**PLANNED UNIT DEVELOPMENT
& SUBDIVISION STAFF REPORT****Date: July 20, 2006**

DEVELOPMENT NAME Springhill Estates Subdivision, Unit Number One,
Resubdivision of a Portion of Lots 14 & 15

APPLICATION NUMBER 27 & 28 DATE July 20, 2006
APPLICANT Springhill Estates Subdivision, Unit One, Resubdivision of a Portion of Lots 14 & 15
REQUEST Subdivision, Planned Unit Development

SITE PLAN

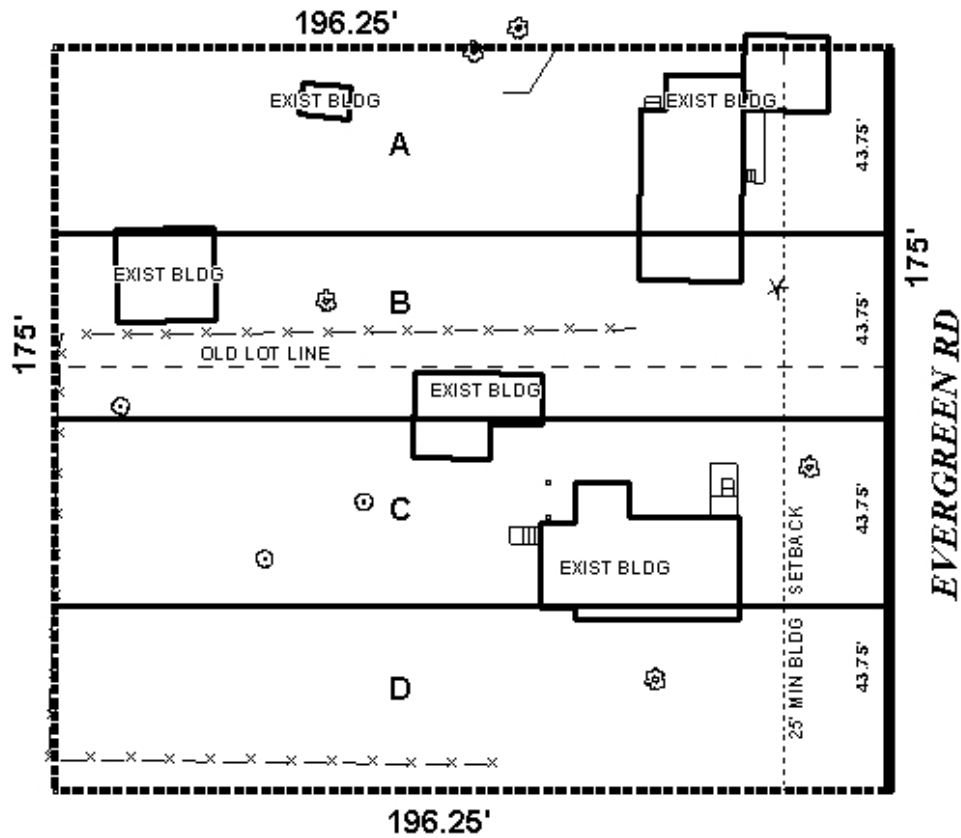
The applicant seeks to subdivide two parcels into 4 lots, and develop single-family residential "patio" homes on each lot. Each lot would be 43.75 feet wide and 196.25 feet deep, and have a zero-foot side yard setback on one side, and a 5-foot side yard setback on the other side. Each lot will be approximately 8,585 square feet.

The site fronts Evergreen Road, a minor street lacking adequate right-of-way. Evergreen Road does not have curb and gutter, thus the right-of-way should be a minimum of 60 feet instead of the existing 40 feet. Sufficient right-of-way should be dedicated to provided 30 feet of right-of-way, as measured from the centerline of Evergreen Road.

Section V.D. of the Subdivision Regulations require lots to be a minimum of 60-feet in width. The depth to width ratio is generally recommended to be 3.5 or less. With a proposed lot width of 43.75 feet, the depth to width ratio will be approximately 4.48.

The Zoning Ordinance requires the following setbacks in an R-1 district: front – 25 feet, side – 8 feet minimum, with 12 feet other side, and rear – 8 feet. Typically, reduced setbacks for a development are applied to internal lot lines, not to property lines that form the perimeter of the

PUD. This application, as submitted, would result in zero and 5 foot side yard setbacks occurring adjacent to existing single-family homes.

As proposed, the PUD and Subdivision request appears to be incompatible with the majority of the development on Evergreen Road. Specifically, the property widths would be substantially less than surrounding properties and the requirements found in the Subdivision Regulations, the depth to width ratio would exceed that recommended in the Subdivision Regulations, and the side yard setbacks would be substantially less than found on surrounding properties.

Planned Unit Development: Based upon the preceding, this application is recommended for Denial for the following reasons: 1) the reduced side yard setbacks and reduced lot widths would be incompatible with the majority of the existing residential development on Evergreen Road.

Subdivision: Based upon the preceding, this application is recommended for Denial for the following reasons: 1) does not comply with the minimum required lot width specified in the Subdivision Regulations; and 2) does not comply with the depth to width ratio recommendation within the Subdivision Regulations.
